SGS 7 – 09

**Proposal on Drafting Hydrogen
Storage System Part of the HFCV-gtr**

21 SEP, 2009

JASIC

Proposal for the 5.1.2.2.1 Verification Test for Performance Durability (sequential hydraulic tests)

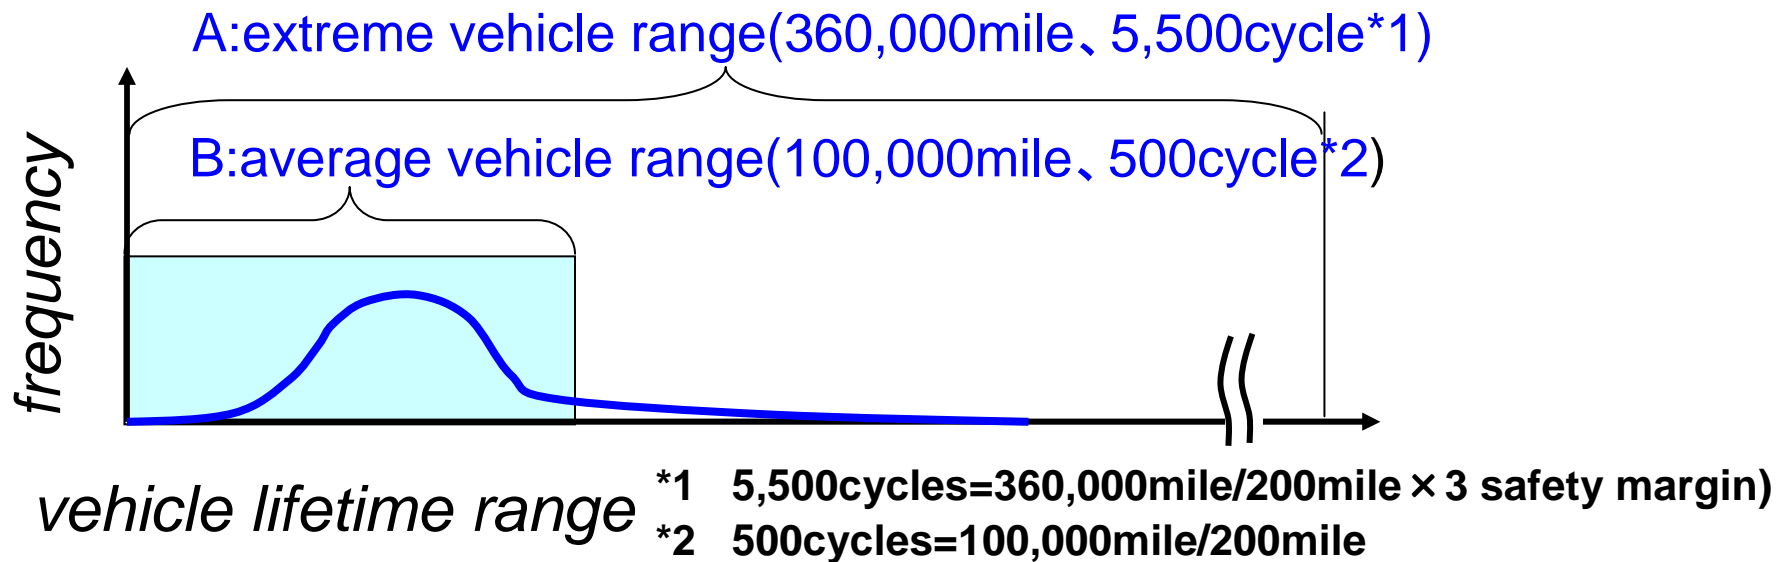
/JASIC propose to change the 5.1.2.2.1

/ JASIC think hydraulic test(5,500cy) with extreme temperature and static pressure test of 1000hr and 85C is appropriate to validate the safety at end of life(15 years, extreme vehicle range).

/JASIC think the purpose of pneumatic cycle test (500cy) is not to validate the end of life safety.

/Pneumatic cycle test(100,000mile=500cycle) is appropriate to validate the fails which could not be validated by hydraulic test.

Proposal for the 5.1.2.2.1 Verification Test for Performance Durability (sequential hydraulic tests)

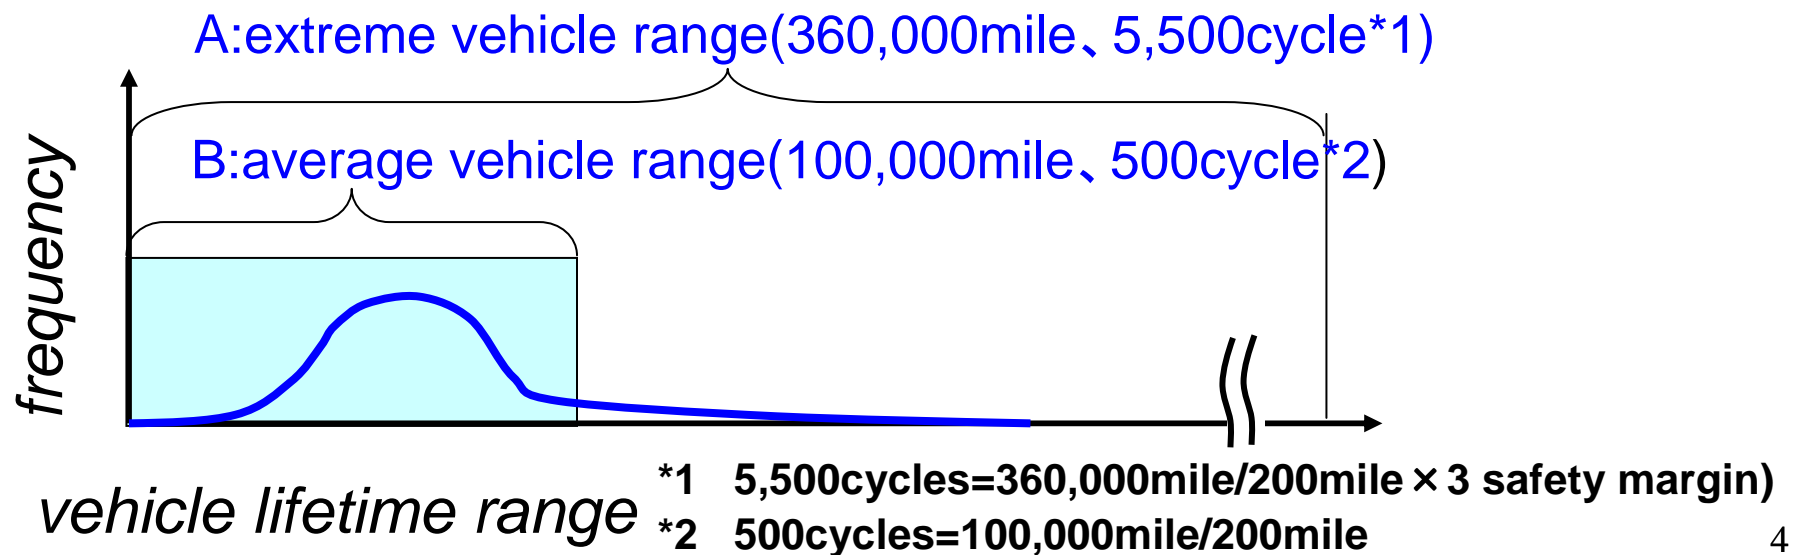
/JASIC propose to change the 5.1.2.2.1

SGS-6-1 draft	proposal	comment
5.1.2.2.1	Hydraulic Cycle Sequential Test (5,500cy) -ambient temperature	1)Hydraulic Cycle Sequential Test (5,500cy) -extreme temperature 2) Add static pressure test of 1000hr and 85C.	Hydraulic test(5,500cy) with extreme temperature and static pressure test of 1000hr and 85C is appropriate to validate the safety at end of life(15 years, extreme vehicle range).

Proposal for the 5.1.2.2.1 Verification Test for Performance Durability (sequential hydraulic tests)

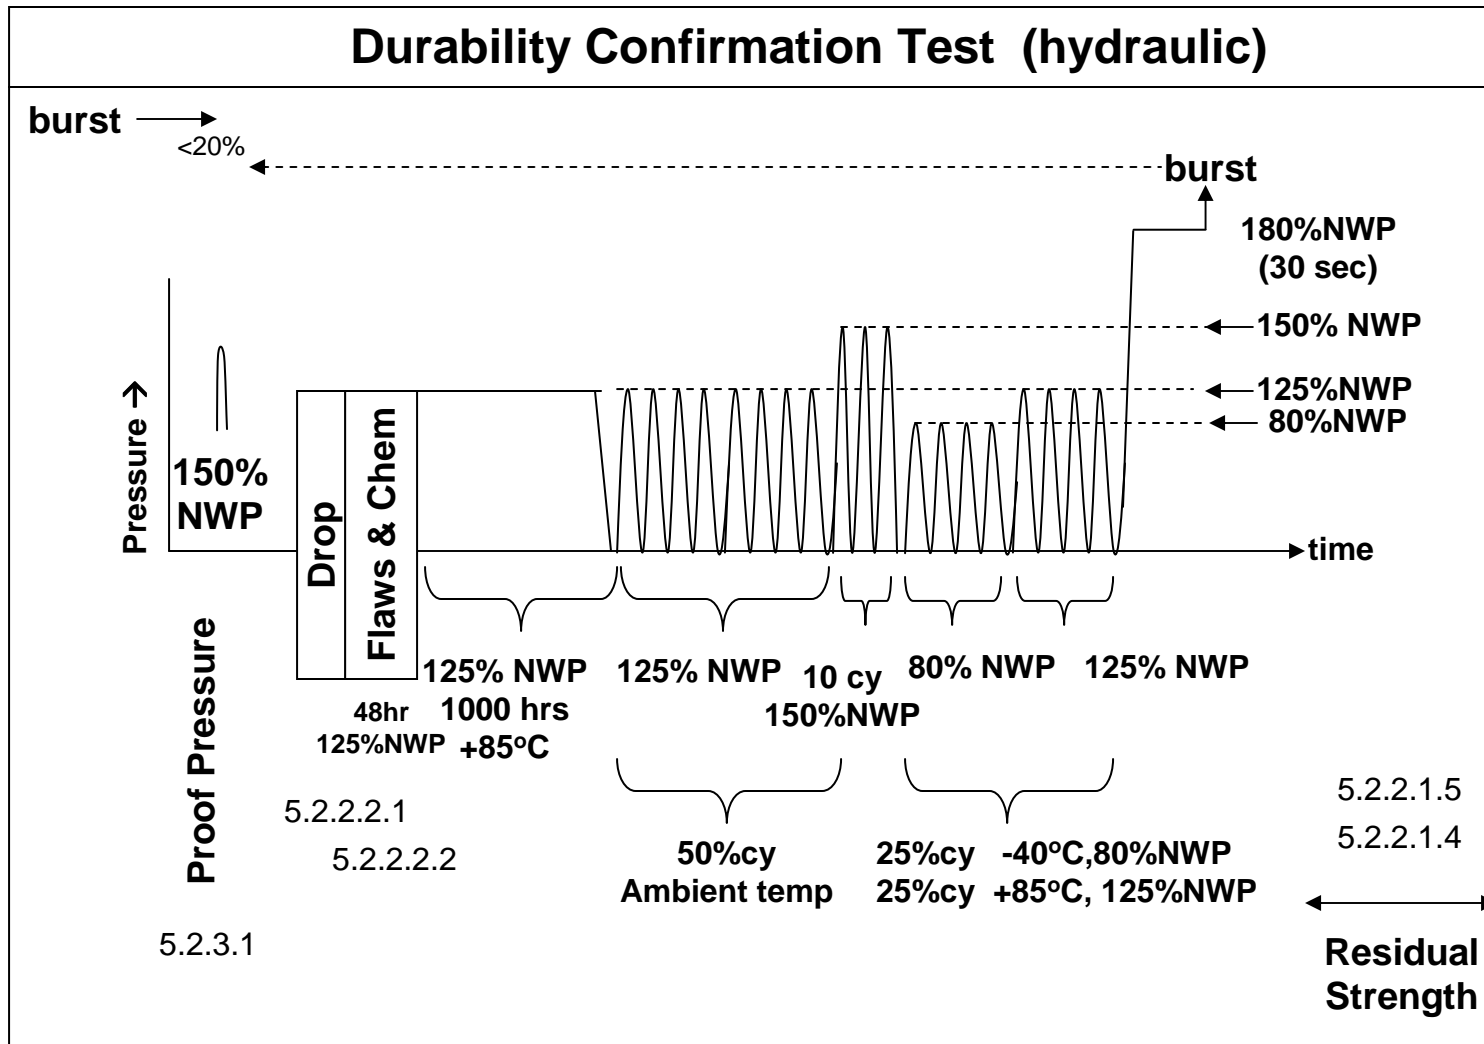
detailed condition should be discussed
